CERTIFICATE OF APPROPRIATENESS

Property: 7815 Santa Elena St, lot 4, block 22 in the Glenbrook Valley Subdivision. The property includes a

Proposal: Alteration – Door and Windows:

April 21, 2022 HPO File No. 2022_0033 Dr Glenbrook Valley

PROPOSED REPLACEMENT DOOR

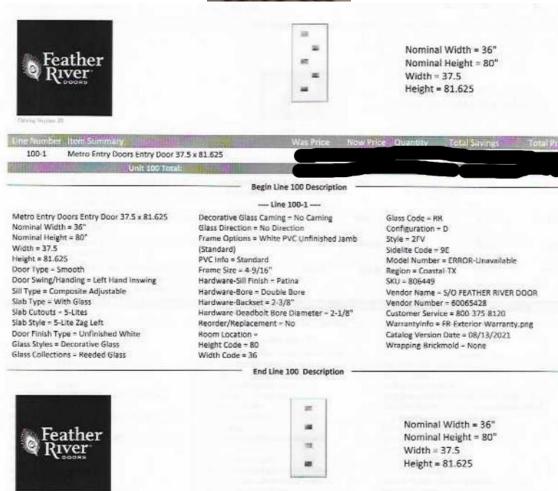
(6)	New materials to be used for any exterior feature excluding what is visible from public alleys must be visually compatible with, but not necessarily the same as, the materials being replaced in form, design, texture, dimension and scale; The scale of the Don Young windows does not match that of the existing windows. The proposed door is not visually compatible to the type of home.
